Secure 1000 Radiation Emission Measurement

FORM R-0646-1
(Single Pose)

Re: Rapiscan AIT System Radiation Survey Reporting

R-0646-1 Addendum (Documentation Errors)

2. Radiation Leakage Measurement: Survey Table. 2

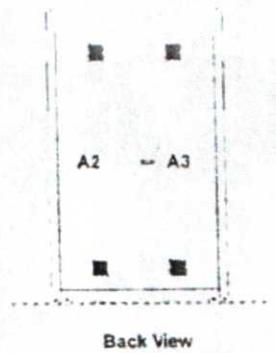
1. TABLE 2: Incorrect presentation of data in Column 3 for Measured Exposure. Indicated value is .1 uRem. The correct value should be 1 uRem.
2. TABLE 2: Incorrect presentation of data in Column 6 for Dose Equivalent. Indicated value is .18 uRem. The correct value should be 1.8 uRem.

The service technician should attend refresher training.

The corrected report indicates the system is within limits for applicable compliance and safety standards. No re-survey is required for this system.
